DART SERVICE INSTRUCTION

TO AMEND INSTALLATION INSTRUCTIONS D350-607-3 Rev.D,
INSTALLATION INSTRUCTIONS D350-607-4 Rev. C AND
INSTRUCTIONS FOR CONTINUED AIRWORTHINESS ICA-D350-607 REV. 6
REF TCCA STC: SH94-14
REF FAA STC: SR00213NY
REF EASA STC: EASA.10016996
REF BRAZILIAN STC: 2007S03-03/-04/-05/-06

A	NEW ISSUE	AJS	14.05.16
REV.	DESCRIPTION	BY	DATE
DESIGN	AJS	DART AEROSPACE LTD HAWKESBURY, ONTARIO, CANADA	
DRAWN	AJS		
CHECKED		DRAWING NO.	REV. A
MFG. APPR.	N/A	DSI 9699	SHEET 1 OF 2
APPROVED		TITLE	SCALE
DE APPR.		LUG REPLACEMENT	NTS
DATE	14.05.16	COPYRIGHT © 2014 BY DART AEROSPACE LTD THIS DOCUMENT IS PRIVATE AND CONFIDENTIAL AND IS SUPPLIED ON THE EXPRESS CONDITION THAT IT IS NOT TO BE USED FOR ANY PURPOSE OR COPIED OR COMMUNICATED TO ANY OTHER PERSON WITHOUT WRITTEN PERMISSION FROM DART AEROSPACE LTD.

FIGURE 1: INSTALLATION OF D4775-041 FWD STRUT

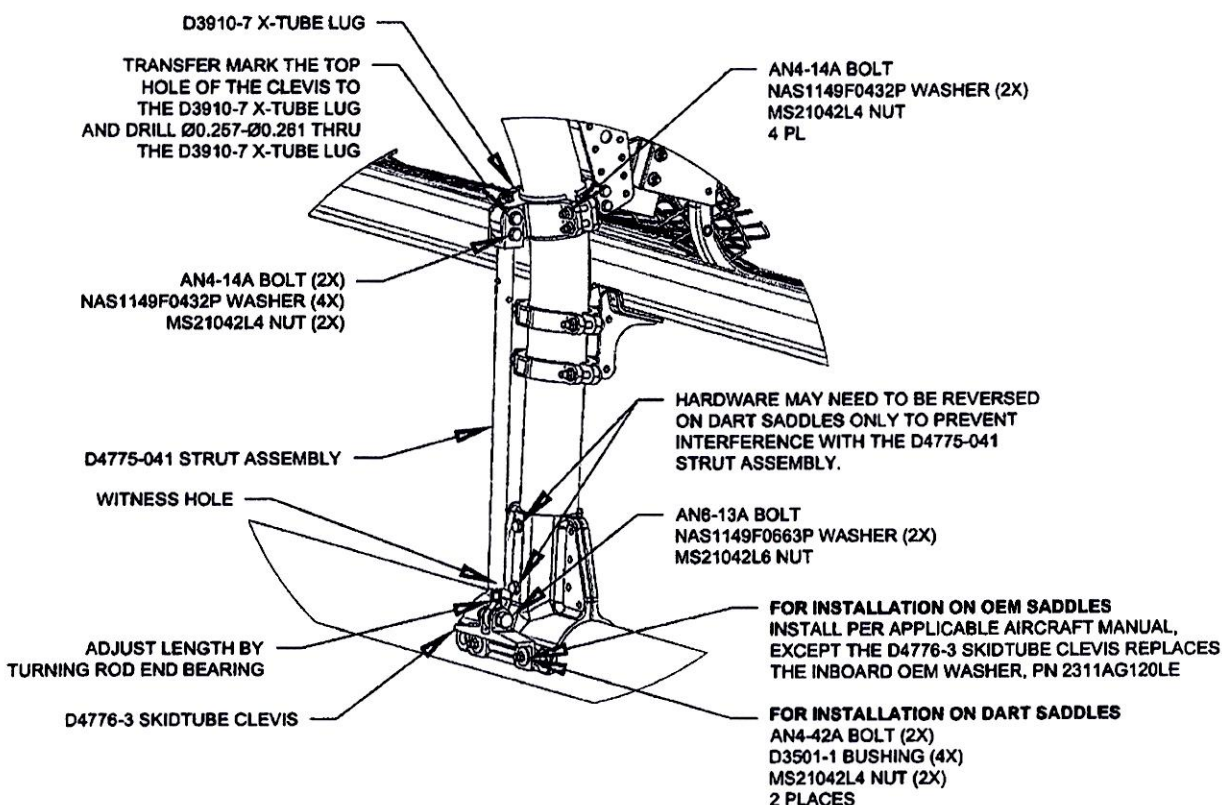
- 3.1 Substitute the Forward Lower D3910-5 X-Tube Lug with the D3910-7 X-Tube Lug as shown in Figure 1.
- 3.2 Install the forward D4775-041 Strut Assembly. Transfer mark from the upper hole on the clevis of the D4775-041 Strut Assembly to the D3910-7 X-tube Lug and drill thru the lug $\varnothing 0.257$ - $\varnothing 0.261$ as shown in Figure 1. Touch up chemical conversion coating per MIL-DTL-5541. Check the witness holes located at the bottom end of the D4775-041 Strut Assemblies to ensure that the thread from the rod end extends past the witness hole.
Torque MS21042L4/-4 nuts to 50-70 in-lbs (5.7-7.9 N-m). Torque MS21042L6/-6 nuts to 160-190 in-lbs (18.1-21.5 N-m).
- 3.3 Complete the installation in accordance with Installation Instructions D350-607-3 Rev. D or D350-607-4 Rev. C.
